APPENDIX D
REPORT OF DESIGN PANEL

The Design Panel was assigned the task of reviewing the design of the systems involved in the Apollo 13 accident, including their qualification history. The service history of the specific components flown on Apollo 13 was also to be examined from a design point of view to ascertain whether any abnormal usage experienced might have had a detrimental effect on the functional integrity of the components. The Panel was also charged with review of other spacecraft systems of similar design or function to ascertain whether they contained potential hazards. Finally, the Panel was to analyze, as required by the Board, proposed failure mechanisms to the extent necessary to support the theory of failure.

Figure D3-13.- Heater fan support.

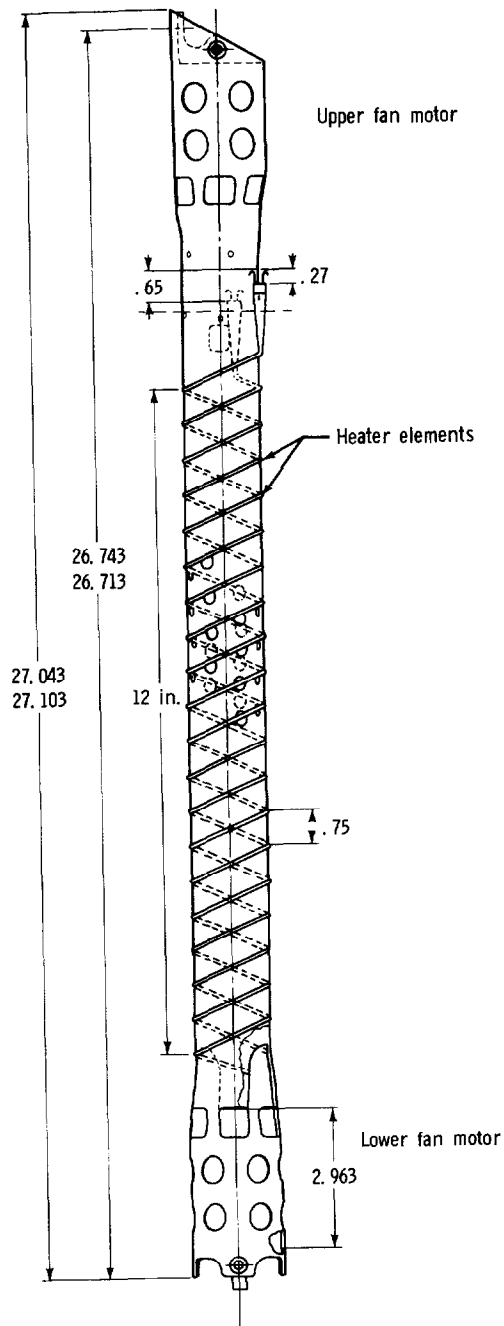
The two electrical heaters (fig. D3-13) are mounted to the heater fan support tube. The heaters are nichrome resistance wire imbedded in magnesium oxide insulation encased within a sheath of stainless steel. The stainless steel sheath is spiralled and brazed to 12.0 inches of the support tube length. The specifications established by North American Rockwell for the Block II EPS cryogenic storage system (ref. 24) provide a requirement for operation of the heater circuit at 65 V dc from a GSE source for initial pressurization of the oxygen tank. For flight the specification calls for operation from a 28 V dc source. The specifications established by Beech Aircraft Corporation for the heater (ref. 25) stipulate standby operation from an ac source, later established as 65 V ac, for 50 minutes. While the heater is apparently satisfactory for its intended use, the specifications are not compatible with the intended use. The heater circuit is protected by a 15-ampere circuit breaker. Individual thermostats for each heater are also mounted on the inside of the support tube.

Figure D3-14.- Cross section of thermostat.

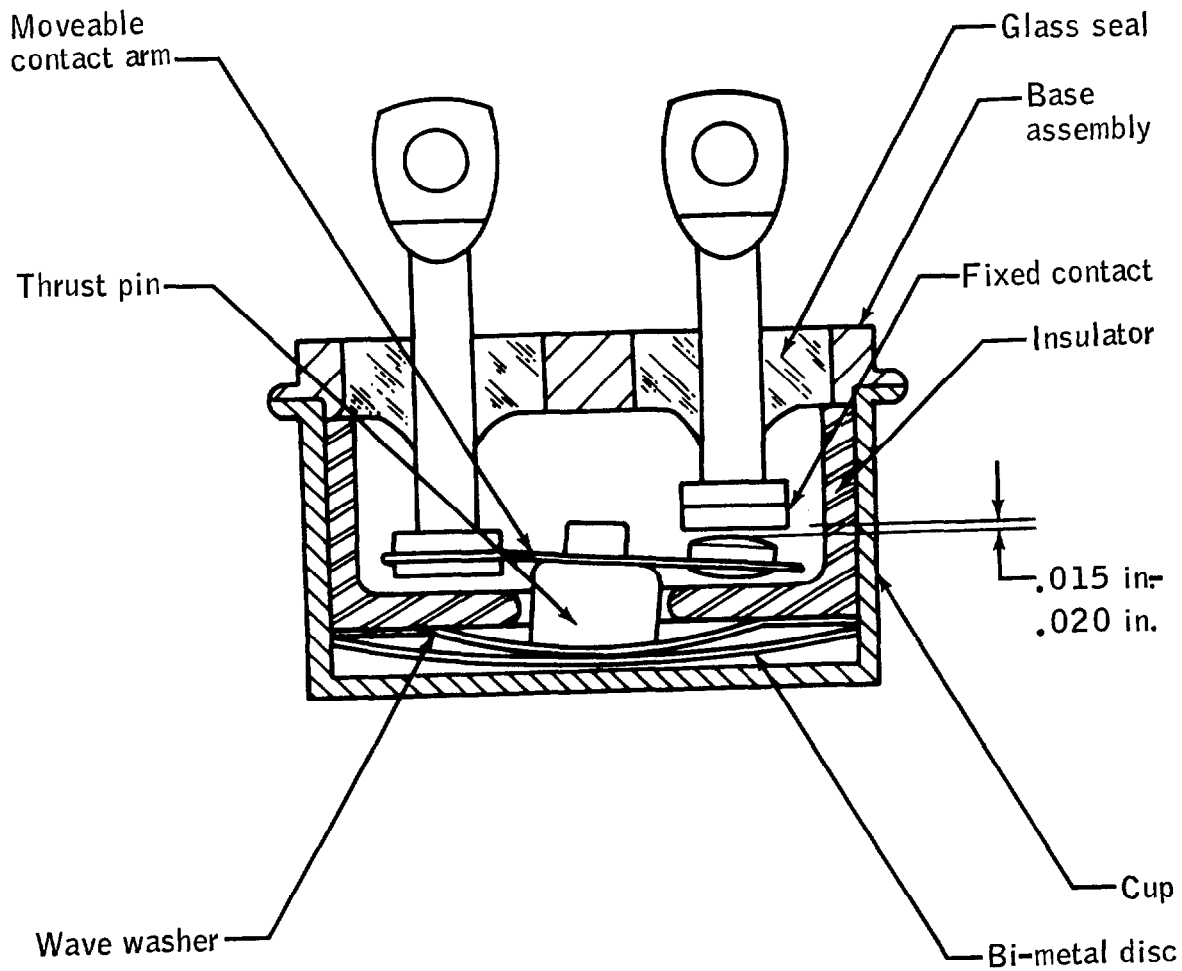
A cross section of a thermostat is shown with the contacts in the open position in figure D3-14. The contacts would assume this position when the temperature of the thermostat reached $80^{\circ} \pm 10^{\circ}$ F. When the thermostat temperature is reduced to $60^{\circ} \pm 7^{\circ}$ F, the differential contraction of the two metals of the bimetallic disc causes the disc to snap through, assuming a convex up configuration. This forces the wave washer and the attached thrust pin to move upward. The movable arm containing the lower contact is pushed up by the thrust pin and the contacts are closed. The wave washer acts as a spring to keep the thrust pin bearing against the bimetallic disc. All of the moving parts of the thermostat are enclosed in an hermetically sealed case.

The combination of incomplete, unclear, and therefore inadequate specifications of the thermostat with respect to voltage type and level and a test program that does not verify the ability of the switch to operate satisfactorily under service conditions constitutes a design deficiency. The fact that the ratings for the thermostat by the manufacturer (preceding table) contains no entry for 65 V dc indicates that service at this voltage was not intended.

Figure D3-16.- Oxygen tank wiring distribution.

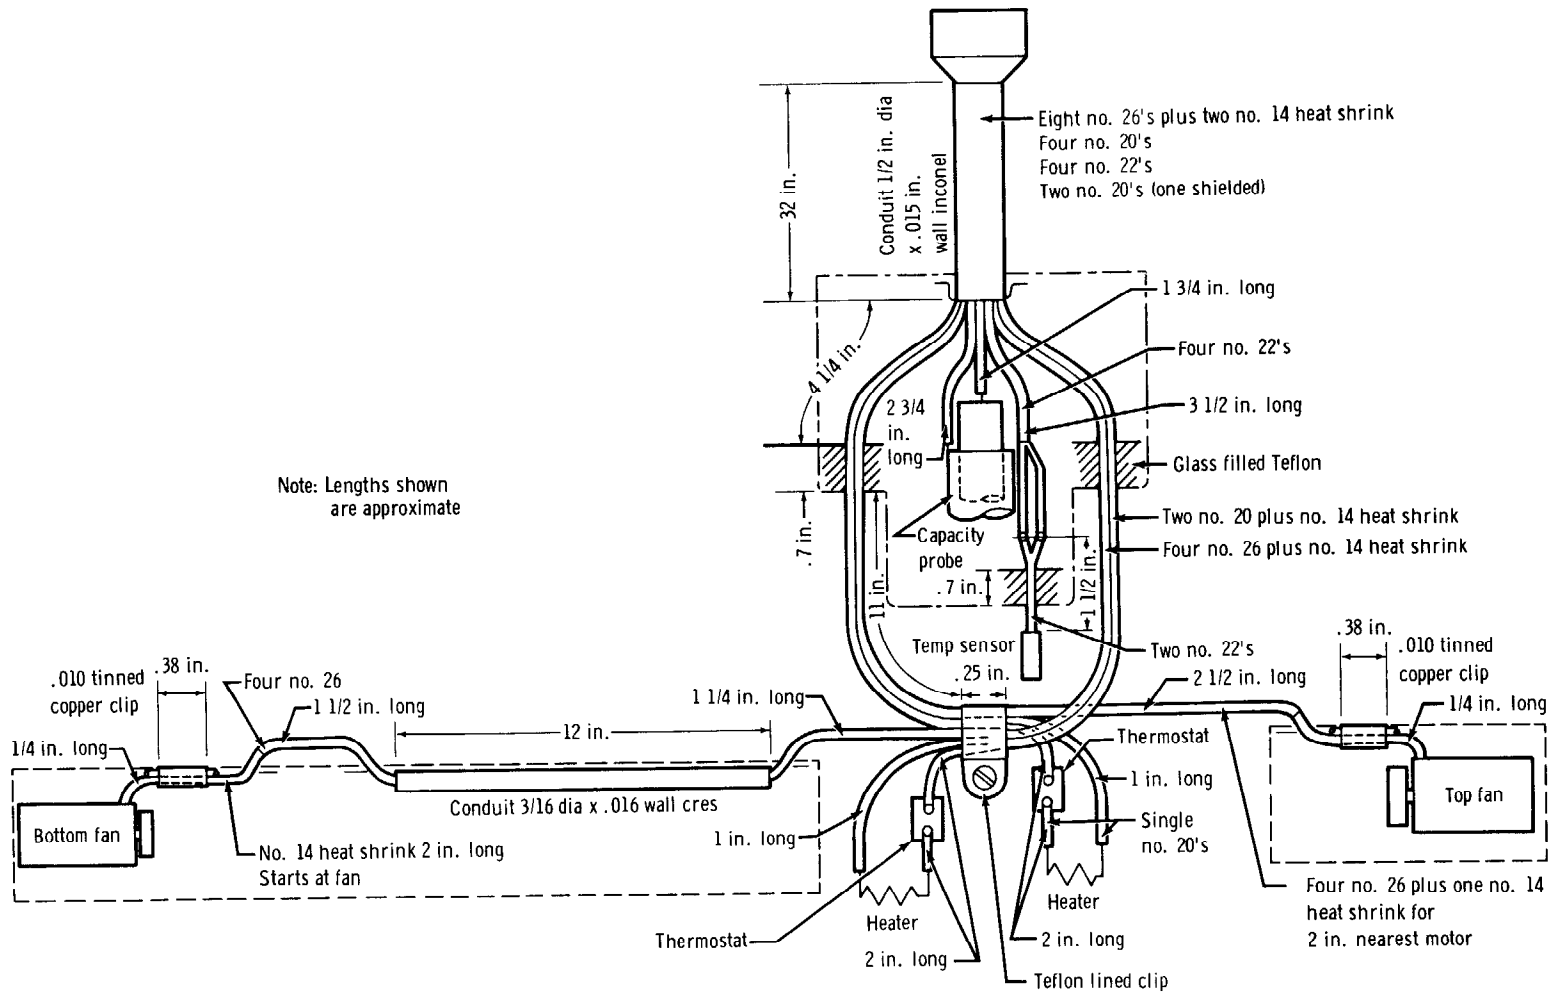
The mechanical design of the tank with respect to provisions for wiring is considered deficient. Damage to the wiring may be either insulation damage or conductor damage, portions of which cannot be inspected or adequately tested during or after assembly.

Figure D3-17.- Typical wire routing for fan motor (four times full size).

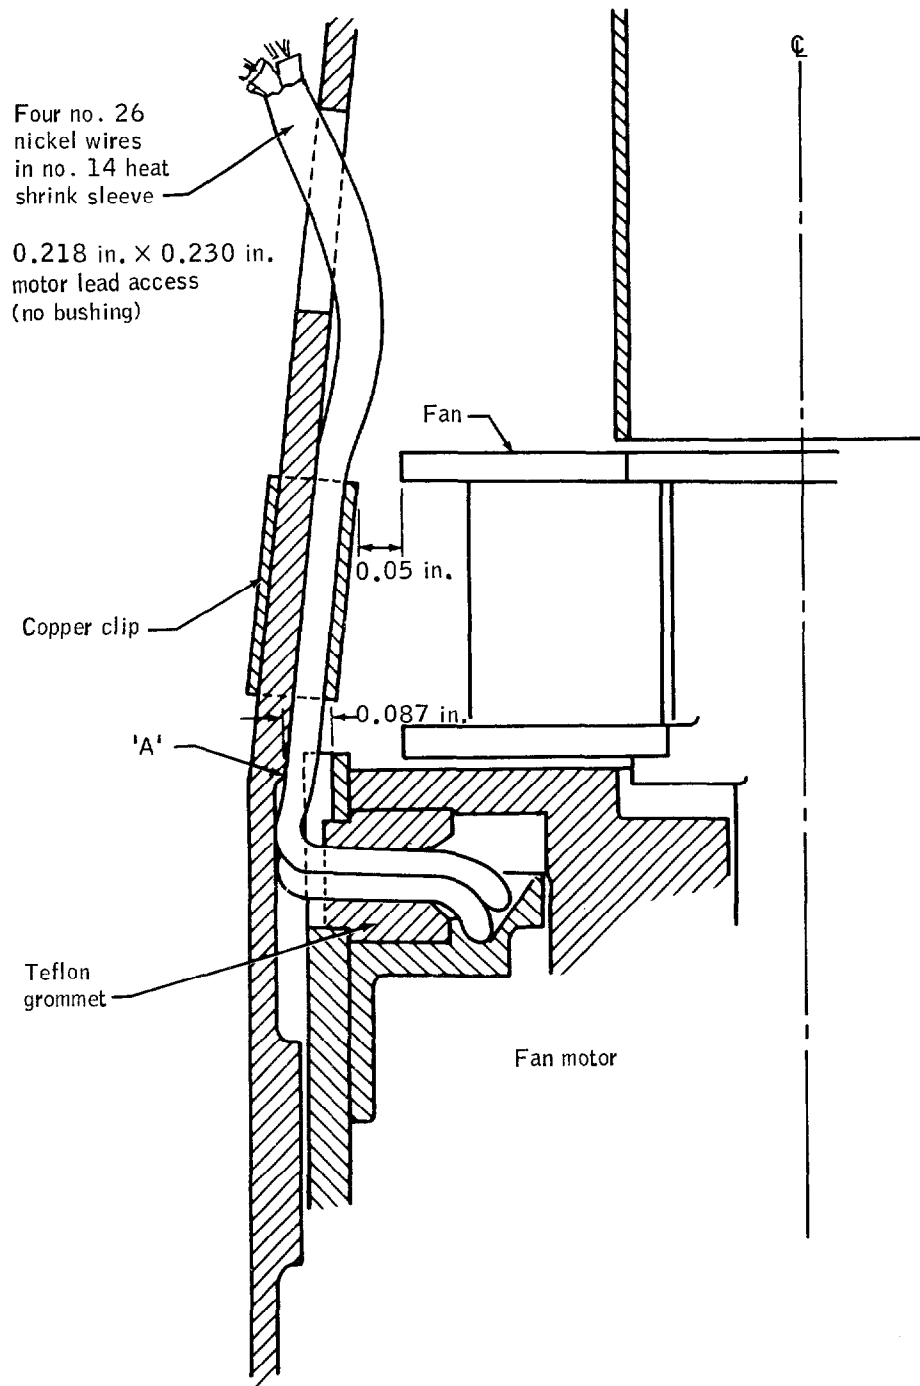
During assembly of the tank, three bundles of six wires each are sequentially pulled through the conduit. The first bundle, consisting of the two quantity gage wires and the four temperature sensor wires, is pulled through the conduit along with the pull wires for the other bundles. The second and third bundles each consist of one set of motor leads encased in 0.012-inch shrink-fit tubing and one set of heater leads. The pull wires have a break-strength of 65 pounds. Since the third bundle of wire must be forceably pulled through the conduit, damage to wires in this bundle or the others may result which may not be detectable without physical inspection. Physical inspection cannot be accomplished with this design.

The calculated break strength of a number 26 AWG nickel wire is 11 pounds and elongation of 28 percent can be experienced before break. If the number 26 AWG wires do not share the load associated with pulling the bundle through the conduit, damage to the wire(s) will result before the pull wire breaks. Stretching of the wire results in local neck-down of both the conductor and insulation. In subsequent operation of the circuit, the locally smaller gage conductor can produce local hot spots and progressive deterioration of the insulation.

Figure D3-18.- Arrangement of head end of tank.

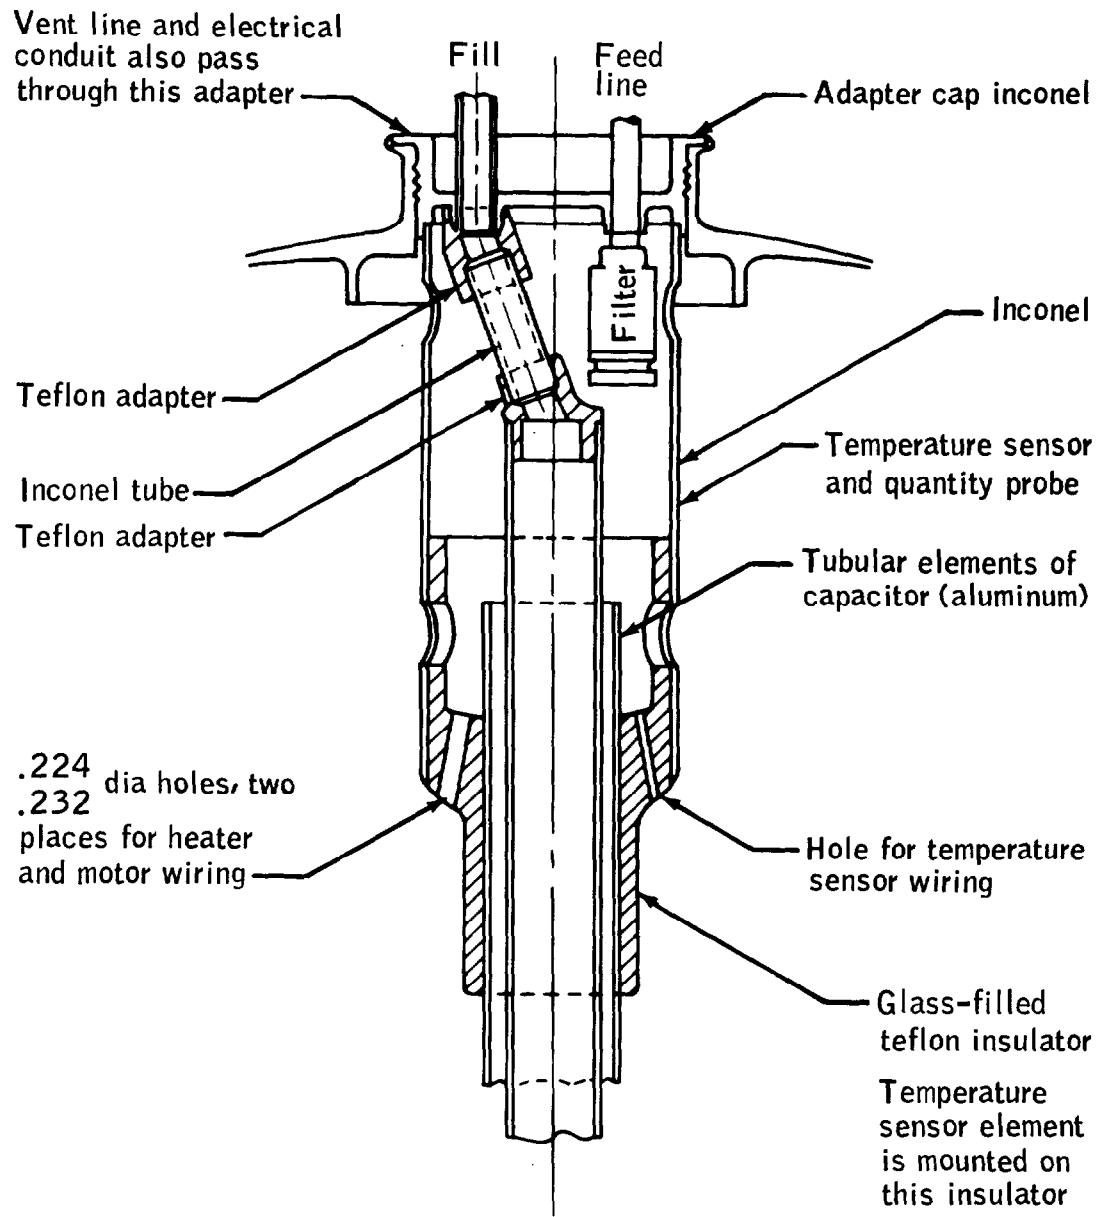
The head ends of the tank and the temperature sensor and quantity probe are shown in figure D3-18. One of the more significant features of the design is the arrangement of the connections in the fill line which routes the cryogenic fluid to the bottom of the tank, via the inner element of the quantity gage capacitor, and which permit the fluid to flow from the bottom of the tank during ground detanking. The manufacturing drawings of the elements of this connection, two Teflon adapters and an Inconel tube, allow a tolerance stack which is excessive. One combined worst case results in a connection which cannot reach from the fill tube connection in the tank head to the center element of the quantity gage capacitor. The other results in a connection length which prevents assembly of the probe to the adapter in the head of the tank. These are shown in figure D3-19. The tolerances on concentricity between the inner element of the capacitor and the outer shell of the probe are not known and are omitted from this figure. Inclusion would show an even worse situation than shown.

One way to obviate this problem would be to redesign the internal components of the tank to permit bench assembly and thorough inspection of a single assembly, embodying all internal components and their plumbing and wiring, before introduction into the tank body. It is recognized that a redesign of this magnitude would largely destroy the foundation of experience, both ground and flight, with respect to the operational characteristics of the tank, but it is difficult to see how the internal details of the tank could be modified to provide the necessary degree of post-manufacturing inspectability without abandoning the present side-by-side arrangement of quantity probe and heater.

Figure D3-19.- Possible variations in fill line connection.

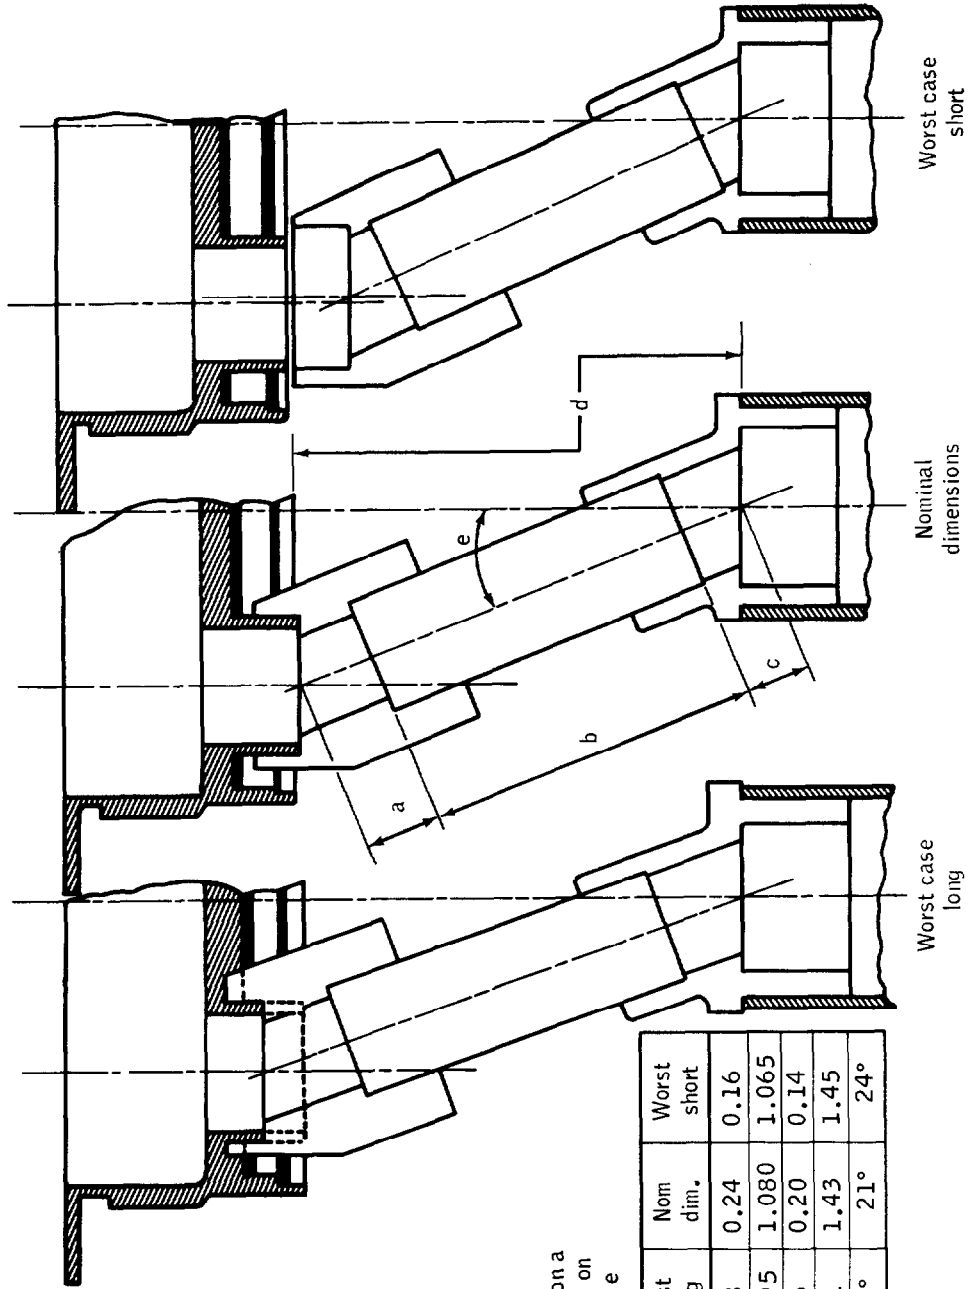
The experience with the oxygen tank no. 2 in Apollo 13 (apparently normal detanking at Beech, but normal detanking not possible at KSC) suggests that the components used in the fill line connection were close to a worst-case short situation. Tests conducted recently at Beech show that near normal detanking is possible when considerable leakage is present at the joints in the connection, and that a substantial displacement of the top Teflon adapter relative to the fill line in the tank adapter cap is necessary to reproduce the KSC situation.

The manufacturing drawing tolerances are such that parts conforming to the drawings could result in an assembly which will not provide the proper connection. However, the probability of a combined worst case is extremely low. It is probable that the actual variations between production parts are significantly less than the drawing tolerances would permit, particularly the variations between parts within a common batch. Data have been requested on other similar parts to determine whether the variations from part to part are large or small, and whether the average tolerance stack found in practice leads to long or short connection assemblies.
